## DEPARTMENT OF PARKS AND COMMUNITY SERVICES

**Subject: Sterling Ranch Sketch Plan Amendment #3, 2<sup>nd</sup> Submittal (SKP-23-005)**

**Sterling Ranch Sketch Plan  
Amendment #3 Review**

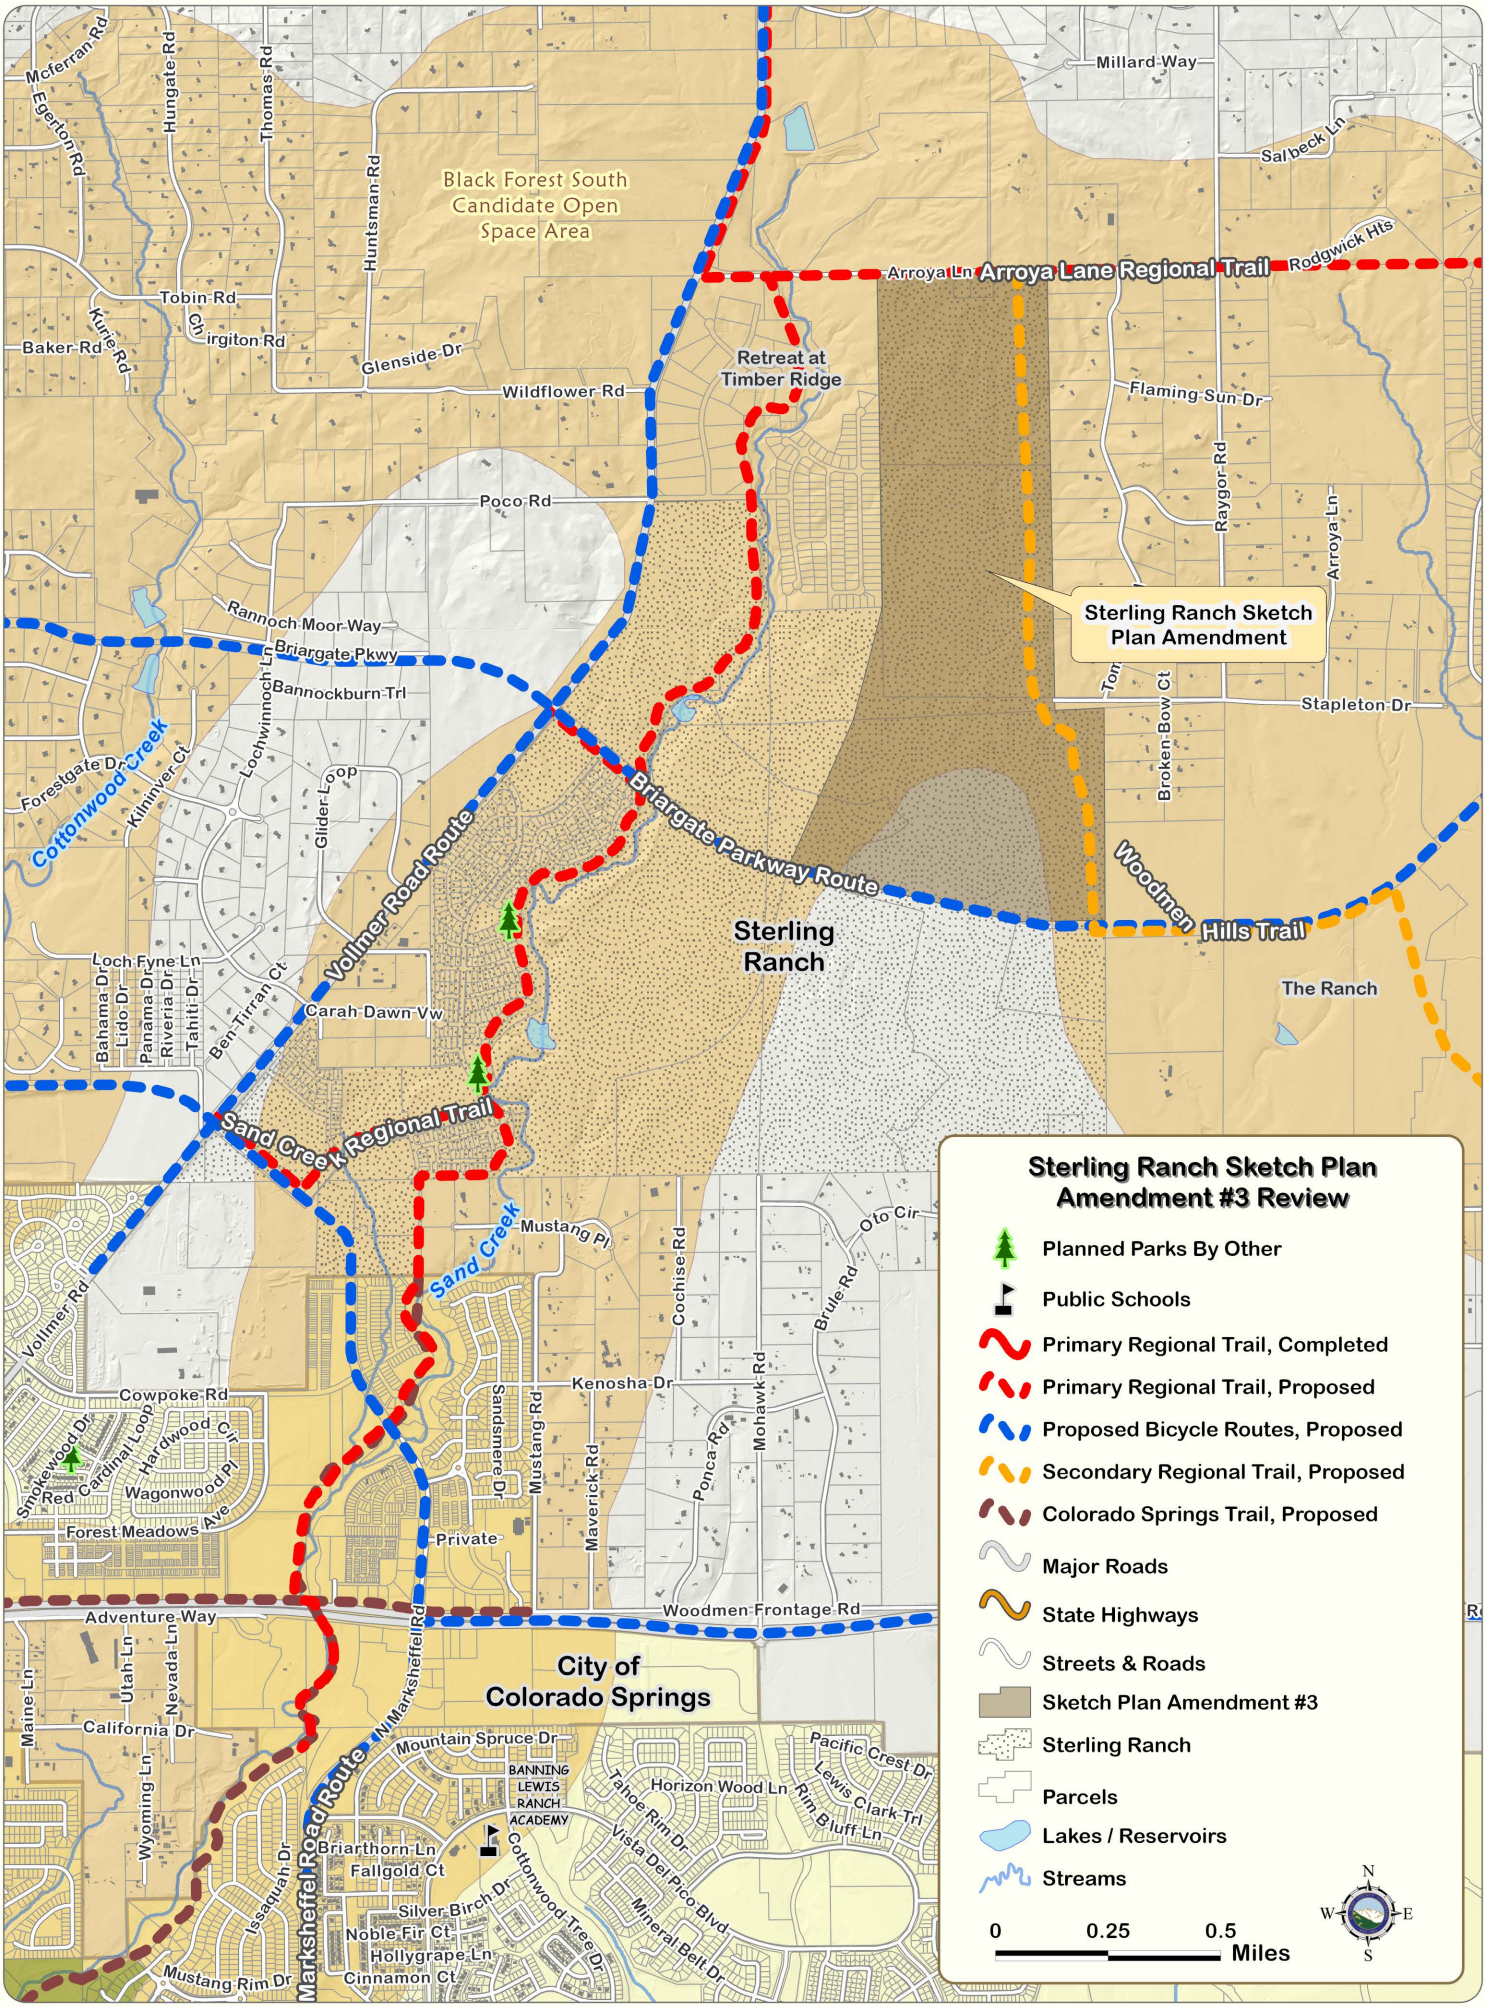
*"The 2022 El Paso County Parks Master Plan shows two proposed regional trail connections and one proposed bicycle route impacted by the project. The proposed Arroyo Lane Primary Regional Trail traverses east/west along the northern property boundary and will provide connectivity to Meridian Ranch to the east and the Sand Creek Regional Trail to the immediate west near the intersection of Arroyo Lane and Vollmer Road. The proposed Woodmen Hills Secondary Regional Trail runs north/south along the easternmost Sterling Ranch property boundary, making vital connections between the Sand Creek and Arroyo Lane Regional Trails in the north, Briargate Parkway to the south, and ultimately, the Rock Island Primary Regional Trail further south within the Town of Falcon.*

*Furthermore, the proposed Briargate Parkway Bicycle Route runs east/west adjacent to the southern side of the Sketch Plan Amendment. A dedicated public right-of-way already exists along the aforementioned bicycle route, so no easement requests are necessary at that location; however, the applicant is advised that multi-modal transportation options will be developed within the rights-of-way in the future, especially given the current development of the Briargate Parkway / Stapleton Road Corridor Study.*

*The 2022 El Paso County Parks Master Plan includes an update to the Candidate Open Space Areas, utilizing a weighted overlay of numerous natural and man-made attributes which contribute to strong candidate open space areas. The Sterling Ranch Sketch Plan Amendment and the three rezoning areas fall primarily within the bounds of the updated Black Forest South Candidate Open Space Area. Open space attribute values here include the Sand Creek corridor, surface water and wetland areas, floodplains, moderate wildlife impacts, and open high prairie grasslands along the southern boundary of Black Forest.*

The Sketch Plan Amendment Letter of Intent highlights the 40-acre open space buffer along the eastern boundary of Sterling Ranch. The Woodmen Hills Secondary Regional Trail is located within this north-south trending open space area, which varies in width from 50' at its northern end to 250' near its intersection with Briargate Parkway. This open space buffer continues to the southeasternmost corner of Sterling Ranch as a location for a neighborhood trail and utilities. Additionally, the Sketch Plan includes a 25' trail corridor along Arroyo Lane to accommodate the Arroyo Lane Primary Regional Trail.

Furthermore, staff encourages the developers to construct internal trail systems that link residents not only to the proposed neighborhood and community parks, schools, and businesses, but also to the County's regional trail system. Lastly, staff recommends that the developers designate and provide to El Paso County 25-foot trail easements along the southern side of Arroyo Lane and through the eastern open space buffer for the purpose of public access, construction, and maintenance of the Arroyo Lane Primary Regional Trail and Woodmen Hills Secondary Regional Trail, respectively.

The Park Advisory Board recommends that the Planning Commission and the Board of County Commissioners include the following conditions when considering and/or approving Sterling Ranch Sketch Plan Amendment #3: (1) designate and provide to El Paso County a 25-foot trail easement along the south side of Arroyo Lane and adjacent water tanks that allows for public access, as well as construction and maintenance by El Paso County of the Arroyo Lane Primary Regional Trail, (2) designate and provide to El Paso County a 25-foot trail easement through the eastern open space buffer that allows for public access, as well as construction and maintenance by El Paso County of the Woodmen Hills Secondary Regional Trail, (3) the easements shall be shown on all forthcoming preliminary plans and final plats, and the aforementioned easements shall be dedicated to El Paso County on the forthcoming final plat(s), (4) fees in lieu of land dedication for regional and urban park purposes will be calculated upon review of forthcoming preliminary plans and final plats, and will be required at time of the recording of the forthcoming final plats. Park Lands Agreements may be an acceptable alternative to regional and urban park fees provided the agreements are approved by the County and executed prior to recording the forthcoming final plat(s)."
